Access Compliance Report

Public Rights-of-Way

(Curb Ramps)

Intersection ID: 18557	Main Street: MILFORD_RD	Cross Street: SENECA_PL	Location: SE
ADA ID: 1CAB68C7880E	Ramp Type: PerpDiag	Initial Pass/Fail: Fail	Overall Compliance: No
Severity Score: 33.75			
Codes/Mitigation Info/Possible Solution		Field Measurements/Component Compliance

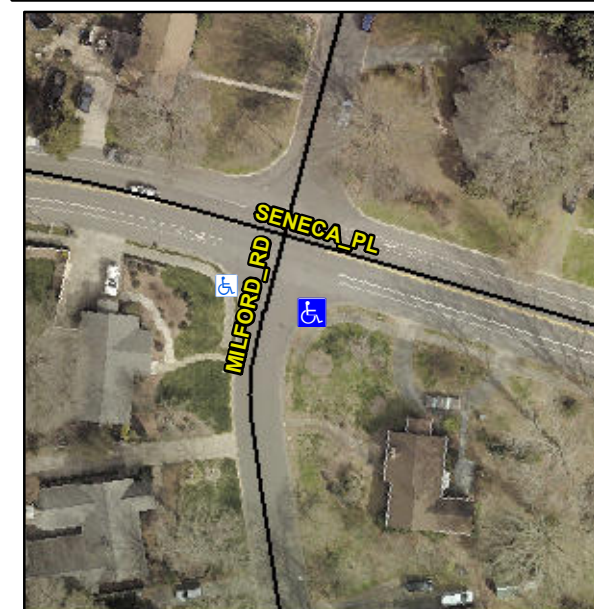
Not Found, R304.5.1, R304.5.3

Compliance	Description	Data	Compliance	Description	Data
N/A	Ramp Length (in)	108.0	Yes	Ramp Slope (%)	5.5
No	Ramp Width (in)	44.0	No	Ramp XSlope (%)	7.2
N/A	Flare Type LT	N/A	N/A	Flare Type RT	N/A
N/A	Flare Slope LT (%)	N/A	N/A	Flare Slope RT (%)	N/A
N/A	Flare Traversable LT?	N/A	N/A	Flare Traversable RT?	N/A
N/A	Landing Length (in)	N/A	N/A	DWS Provided?	N/A
N/A	Landing Width (in)	N/A	N/A	DWS Contrast?	N/A
N/A	Landing Slope (%)	N/A	N/A	DWS Length (in)	N/A
N/A	Landing X Slope (%)	N/A	N/A	DWS Full Width?	N/A
N/A	Landing Curb? (Y/N)	N/A	N/A	DWS Offset (in)	N/A
N/A	Shared Landing?	N/A			
N/A	Gutter Ponding?	N/A	N/A	Gutter Slope (%)	N/A
N/A	Gutter Lip Ht (in)	N/A	N/A	Gutter X Slope (%)	N/A
N/A	Painted X Walk1?	No	N/A	Painted X Walk2?	No
	X Walk 1 Direction	To NE		X Walk 2 Direction	To NW
N/A	X Walk 1 Width (in)	N/A	N/A	X Walk 2 Width (in)	N/A
	X Walk 1 Slope (%)	1.1		X Walk 2 Slope (%)	3.9
	X Walk 1 X Slope (%)	4.5		X Walk 2 X Slope (%)	0.5

Remove & Replace Curb Ramp With Two New Directional Ramps or Equivalent.
